**SUBJ:** Emergency Exits

**SAIB:** AIR-22-04

**Date:** March 14, 2022

Figure 1. External Egress Panel and Emergency Egress Hinge Pin Assembly

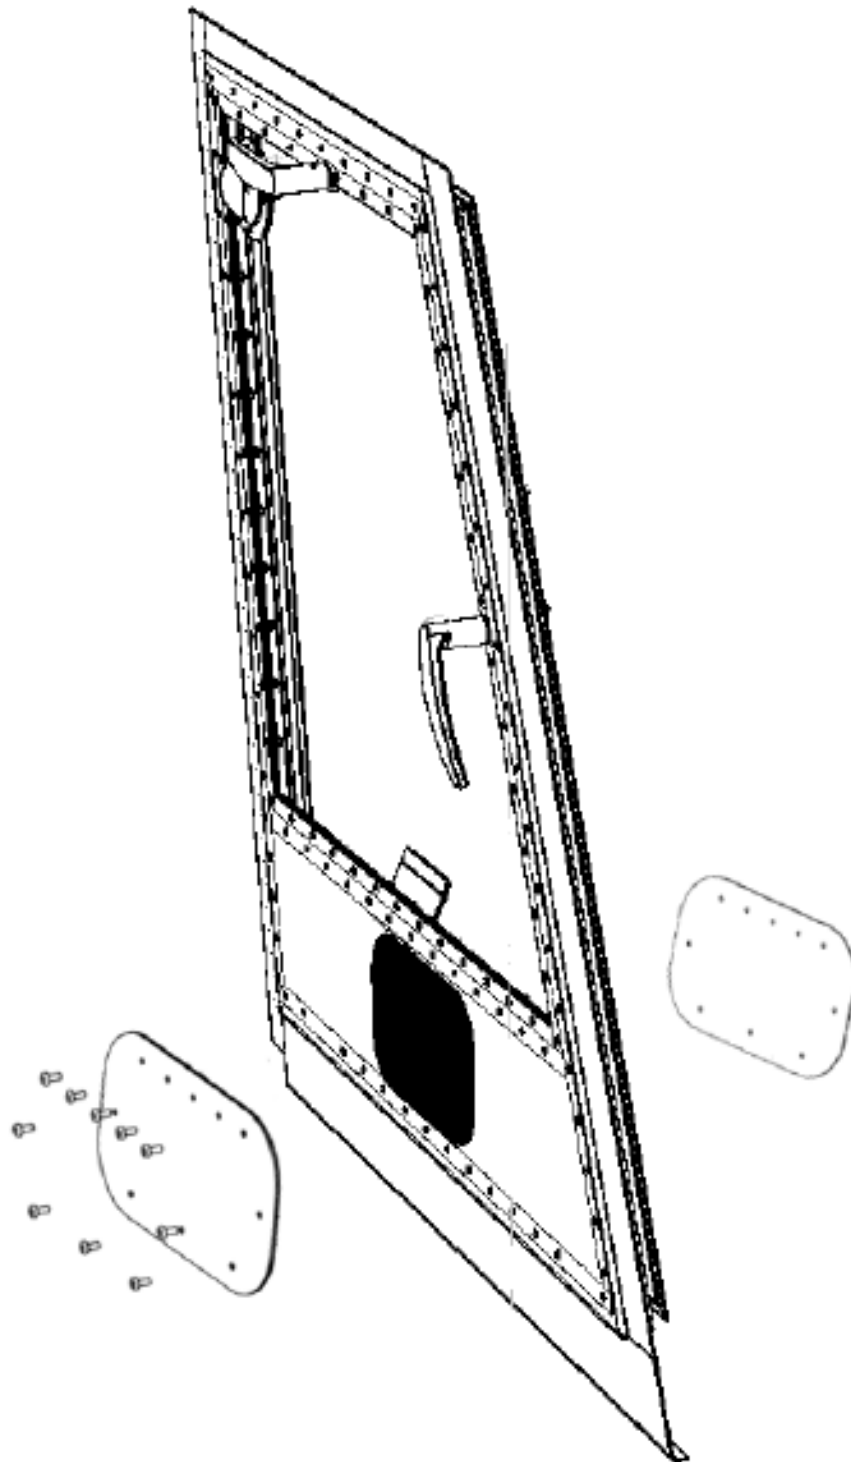
The FAA has received a report of Thrush Aircraft, LLC S2R airplanes having had sealant applied during assembly to the emergency egress panels located on each door. Sealant was applied to prevent water intrusion, but has the unintended consequence of possibly preventing a pilot or occupant from easily pushing through the panel as part of the procedures for emergency egress stated in the airplane flight manual. These procedures require pushing out the panel, reaching through to pull the hinge pin, and pushing the door out.

The issue has since been corrected in manufacturing with a new egress panel assembly. Additionally, Service Bulletin SB-AG-79, dated 01/04/2022, has been released and specifies the necessary procedures for determining if sealant is present and replacing the existing egress panel assembly. See Figures 1 and 2 for location and detail of the emergency egress panel and hinge pin assemblies.

The FAA recommends that all owners and operators of the affected airplanes follow the actions outlined in the referenced service bulletin at the earliest opportunity.
